## Addendum #2 - Bid Package #6929-05

Project Name: Lincoln Public Schools District Office  
5901 'O' Street  
Lincoln, NE  
Project No.: 11065  
Issued: April 3, 2012

**PARTIAL REVISED MAIN FLOOR FOUNDATION AND  
FRAMING PLAN**

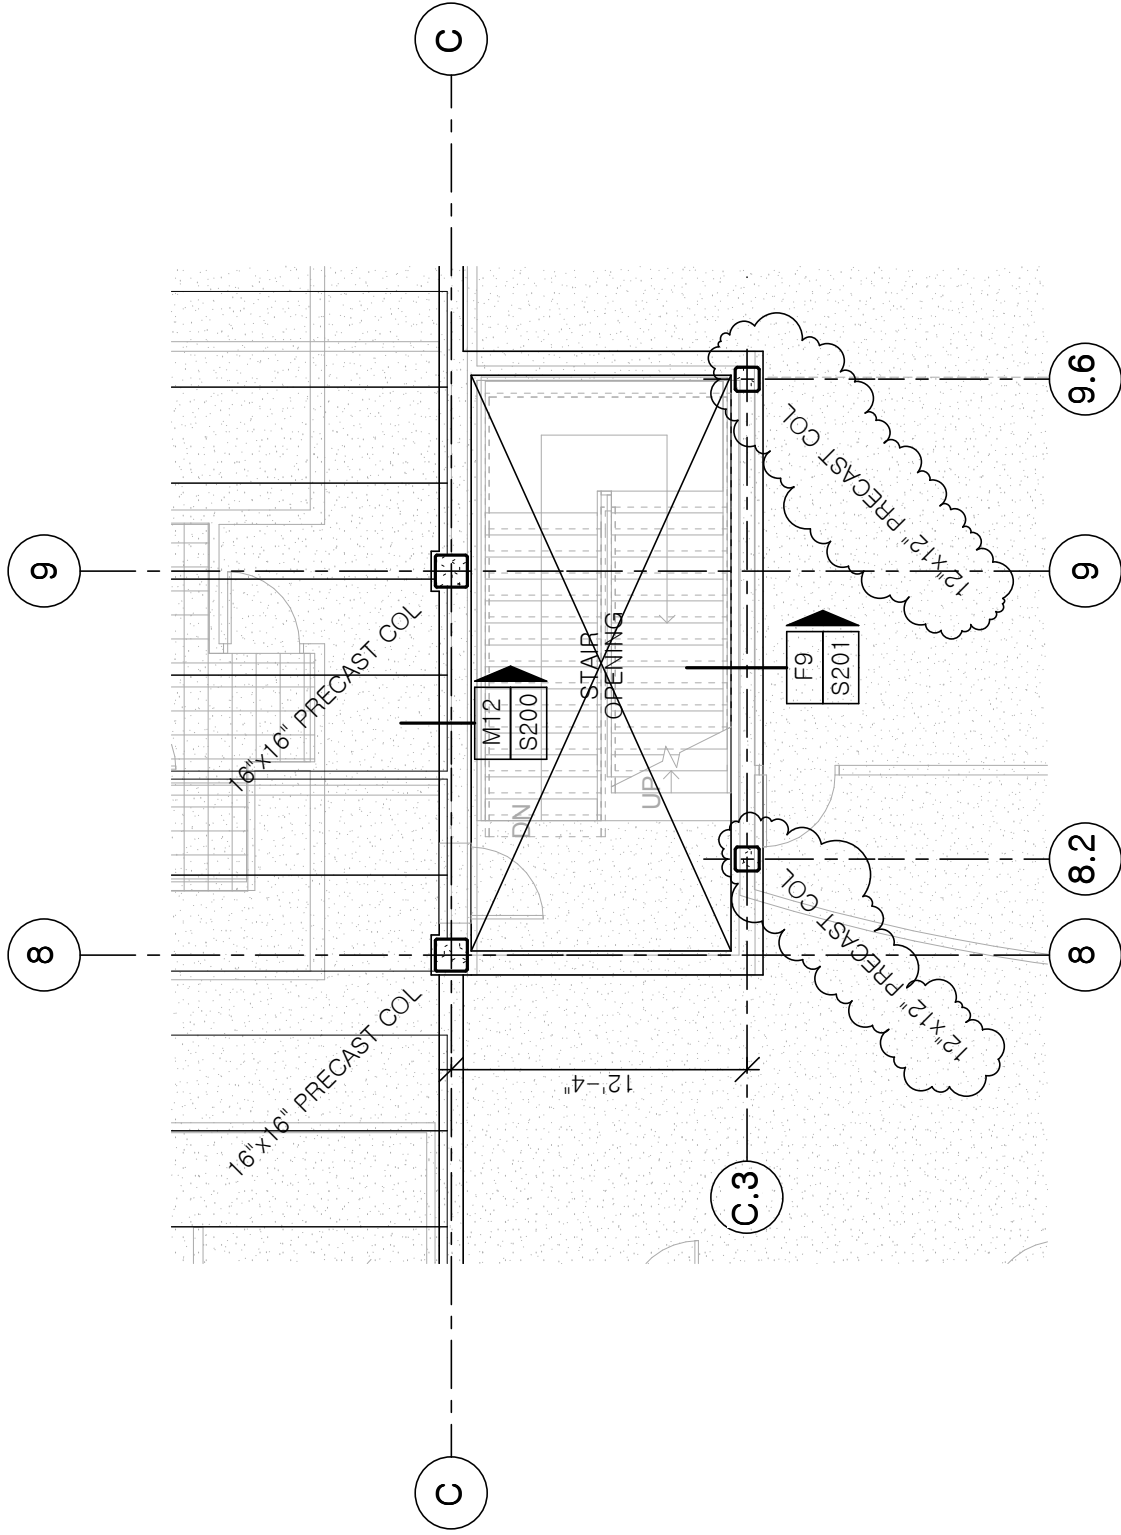
**ADD 2-14.** Refer to Sheet S101; Attached **Sketch aS-14** includes revisions to the main floor foundation and framing plan. Two (2) 12"x12" precast columns have been added.

**PARTIAL REVISED SECOND FLOOR FRAMING PLAN**

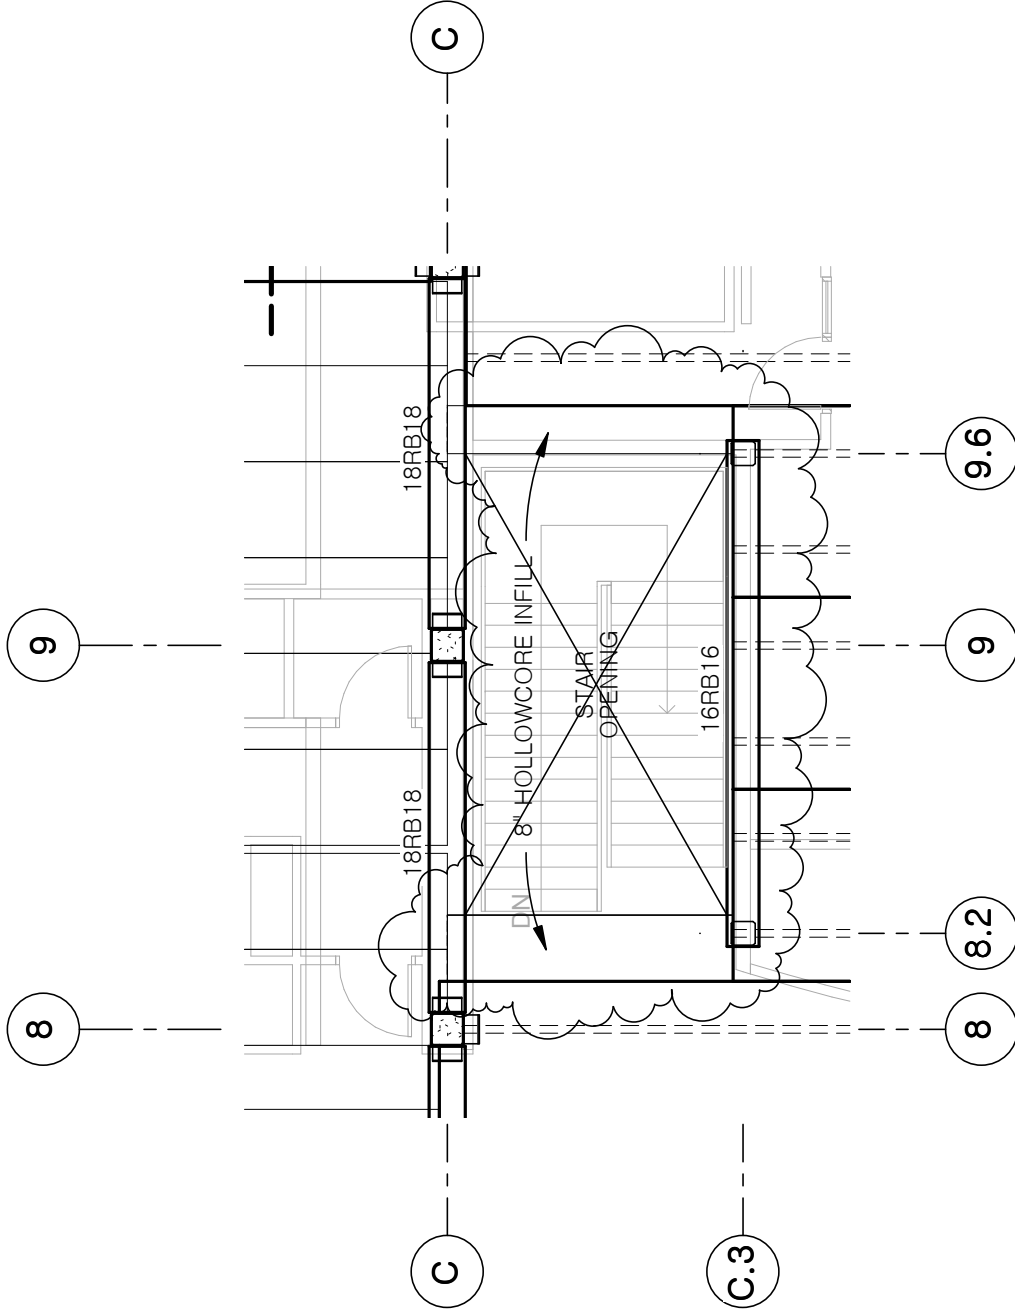
**ADD 2-15.** Refer to Sheet S102; Attached **Sketch aS-15** includes revisions to the second floor framing plan around Stair S1. A rec beam and hollowcore have been added to frame around the stair opening.
